SUNDRY NOTICES AND REPORTS ON WELLS

Navajo Tribal H

6

Re: Permanent Abandonment

Spot surface plug from NAVAJO H-6
100' - surface
TOTAH GALLUP

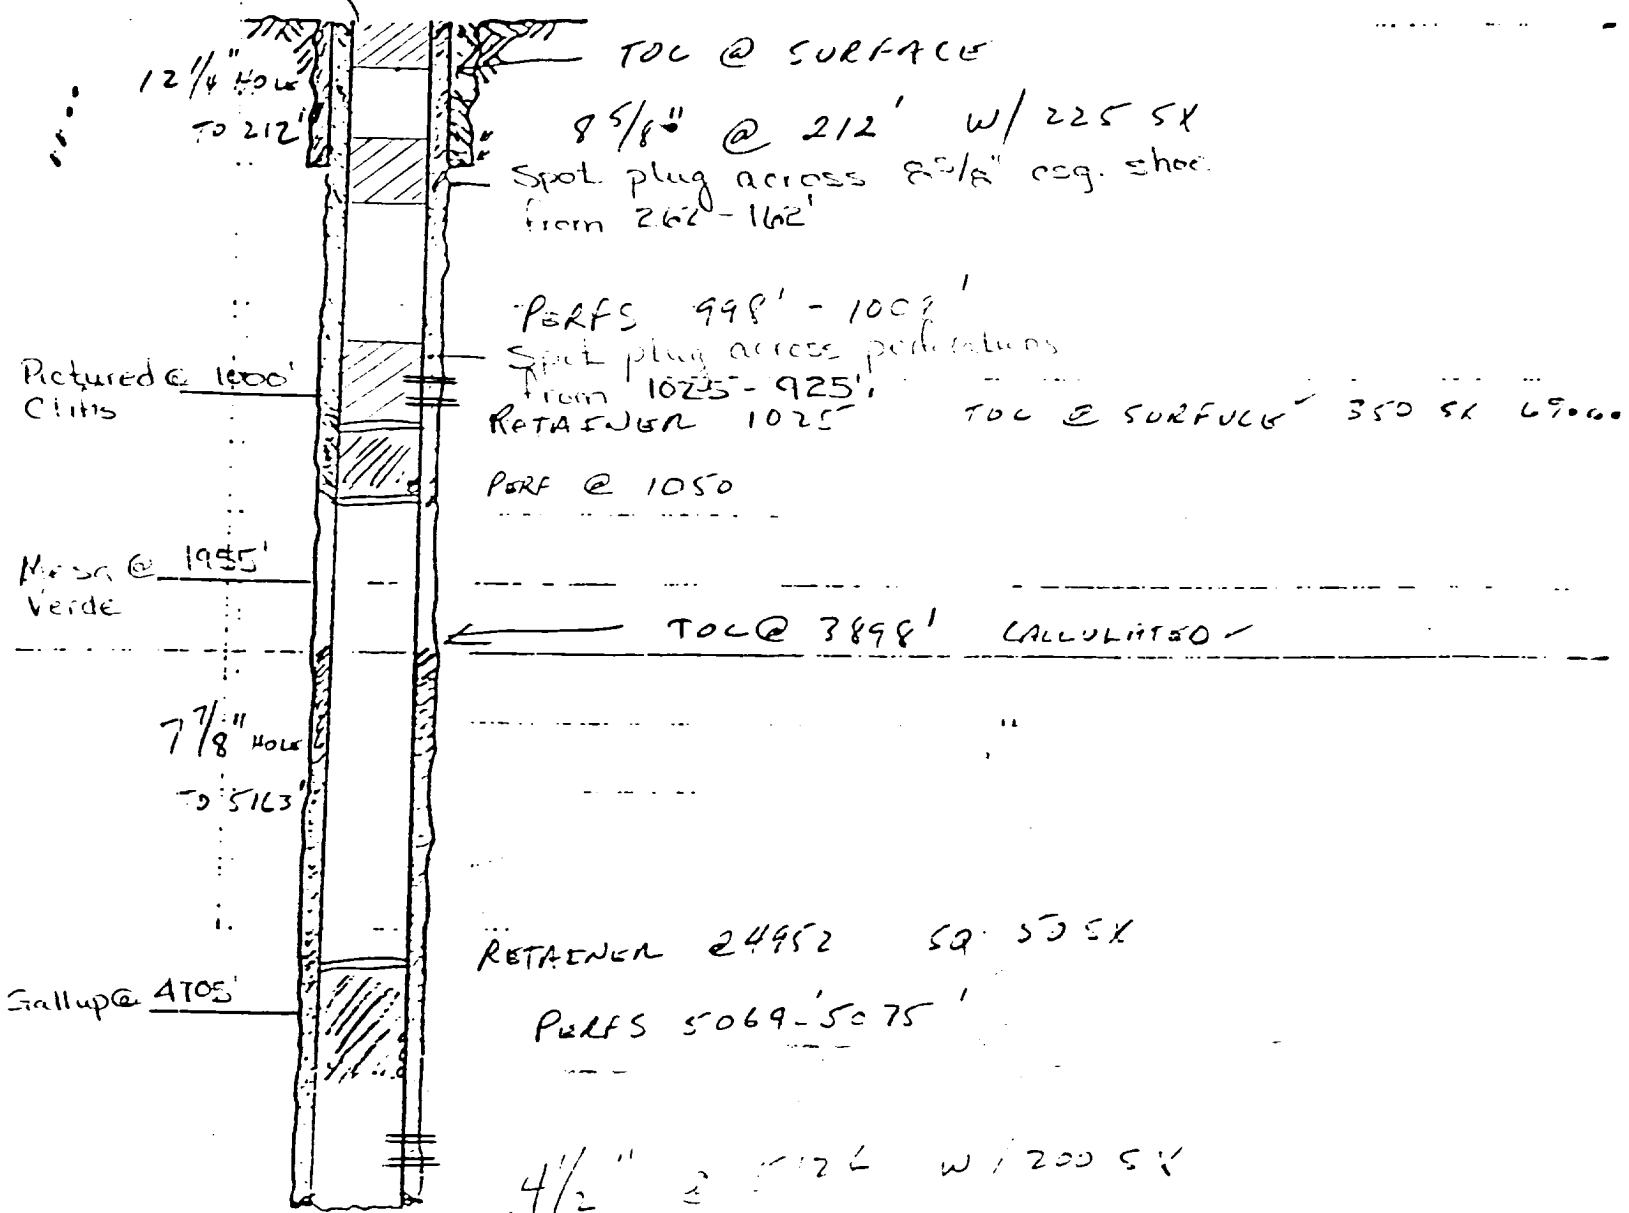
5. The following modifications to your plugging program are to be made (when applicable):

- 1) Spot plug across perforations from 1025' - 925'
- 2) Spot plug across 8 5/8" csg. shoe from 262' - 162'
- 3) Spot surface plug from 100' - surface
